Sheet: /
File: RP2040-Guide.kicad_sch

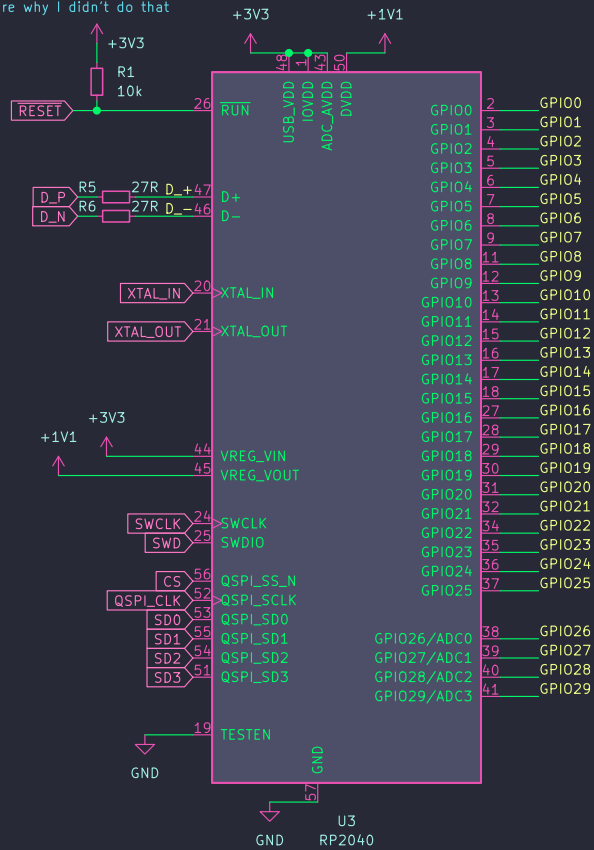
You can probalby replace R1 with a 1k resistor
to use simplify the BOM.
Not sure why I didn't do that
